RE: 1268 Curran Highway – Marijuana Retail Site, Special Permit Amendment
Applicant: Sparkboro Wellness NAMA Corp
Property Owner: Shake and Bake Holdings, LLC

On behalf of Sparkboro Wellness NAMA Corp, Guntlow & Associates Inc. has prepared this letter to request an amendment to the approved project referenced above. See attached revised plans and details.

Site Improvements Plan
PREPARED FOR
Sparkboro Wellness
1258 Curran Highway, North Adams, MA

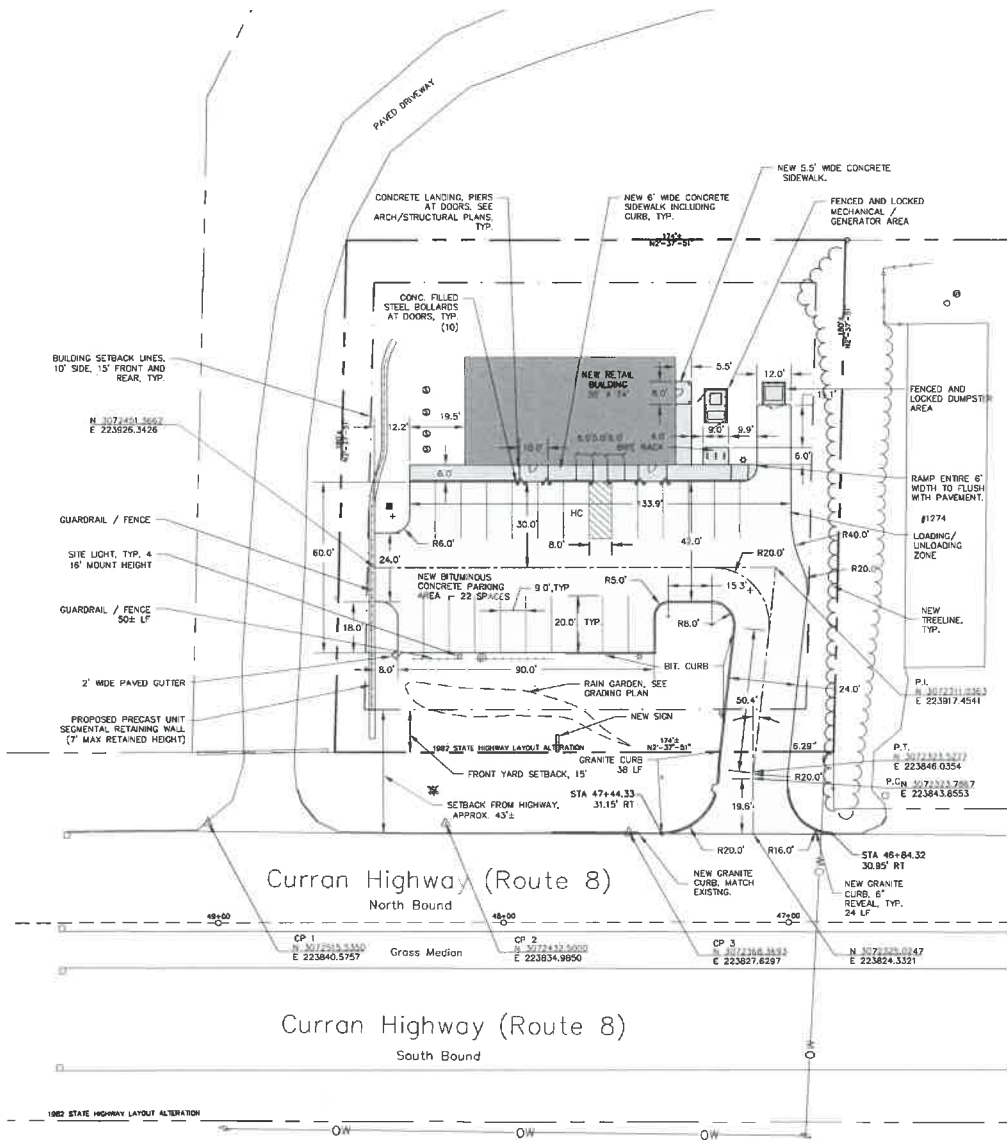
The proposed site sign location is shown on the plans and is located on the subject parcel, not within the Right of Way. The nearest edge of the sign to the curb line of Curran Highway is approximately 28 feet. The front property (right of way) line for this parcel jogs back 20' farther away from the highway than the neighbor to the south, so the sign is near the property line, but not near the road. The proposed free standing sign is 14' high above proposed grade where it is located and the bottom of the sign is 8' above the elevation of the road perpendicular to where it is located. The sign area is 48 square feet. Due to extensive frontage of this parcel, the maximum area for signage on this lot is 200 square feet, 25% of which can be a free standing sign (50 sf). The upper portion of the sign will be lit internally in a manner which will not create a hazard to pedestrians or motor vehicles. The lower portion of the sign will have a LED static message board. We feel the sign as submitted complies with the requirements of sections 7.2 and 7.4.1, as allowed by right. Sign details are included in this package for your review.

- Furnish and install one double-sided sign cabinet. Cabinet measures 72" X 72" X 12" with polycarbonate faces and vinyl graphics
- Furnish and install two single-sided, static electronic message boards, no moving graphics. Each 24" X 72"
- All cabinets to receive black finish
- Pole covered with fabricated 18" X 12" X 72" decorative aluminum cladding with painted finish

2 Proposed Site Utility Plan
C3 1"=20'

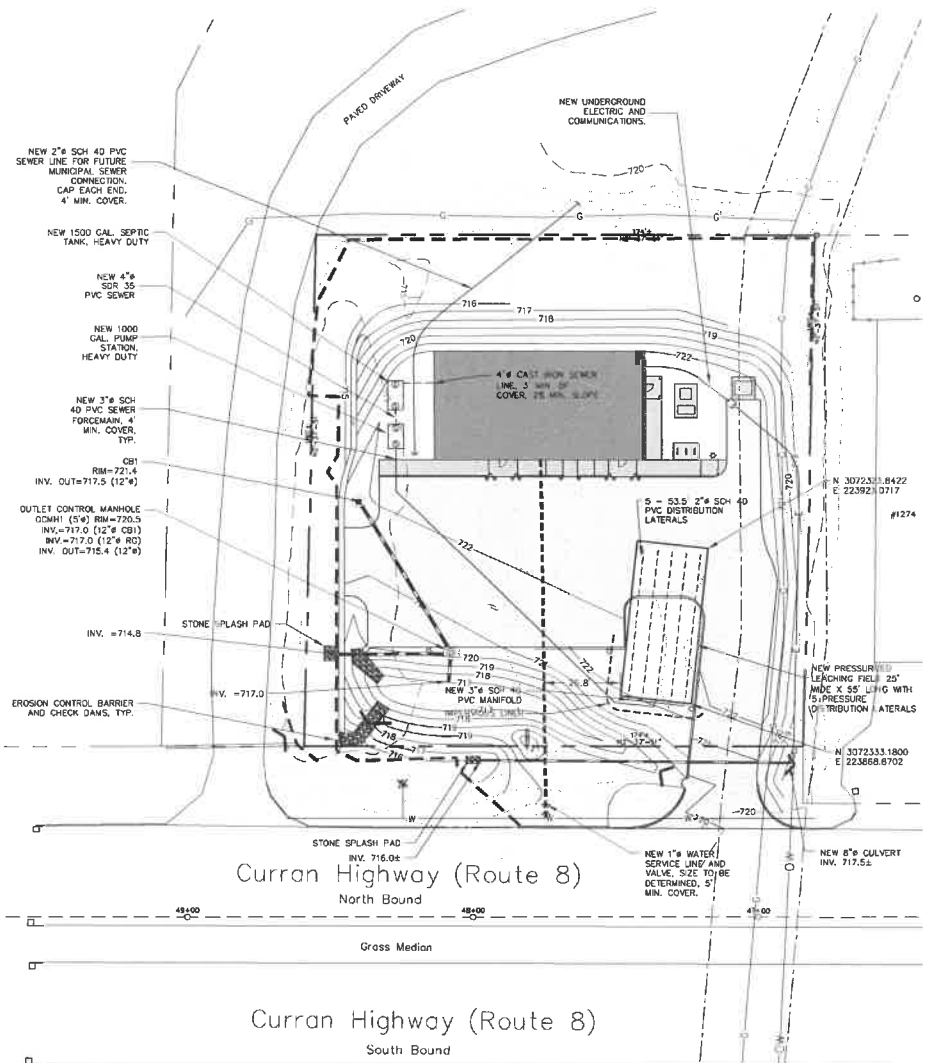
The site utilities were moved around a little to accommodate the new building footprint and we propose a capped sewer forcemain line to the east, under the proposed mitigation area, for a potential future municipal sewer connection option.

2 Bio Retention Area/Rain Garden-Typical Section

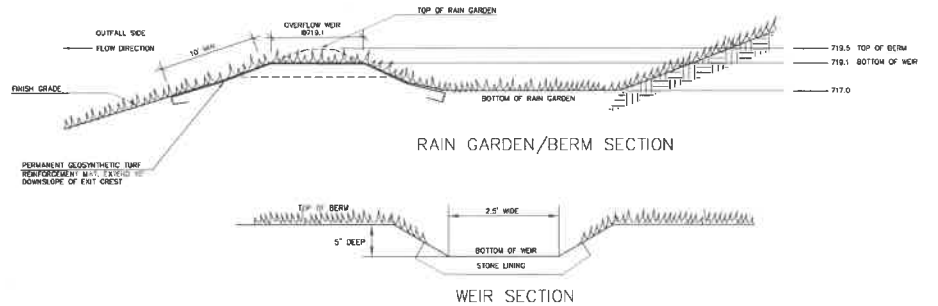
The building modification resulted into a few adjustments to the site plans, primarily involving the stormwater management system. Rather than utilizing a subsurface detention/infiltration area under the proposed parking area, a larger rain garden is now proposed which has been designed to accommodate for the stormwater requirements of the entire site. Ultimately, we believe that traditional detention via a rain garden is a better option compared to subsurface detention, allowing for visual inspections and maintenance that is otherwise complicated for underground facilities. The stormwater report, calculations, and plans have been submitted to the Conservation Commission for their review. We were also able to add one additional parking space, totally 22 spaces on site.
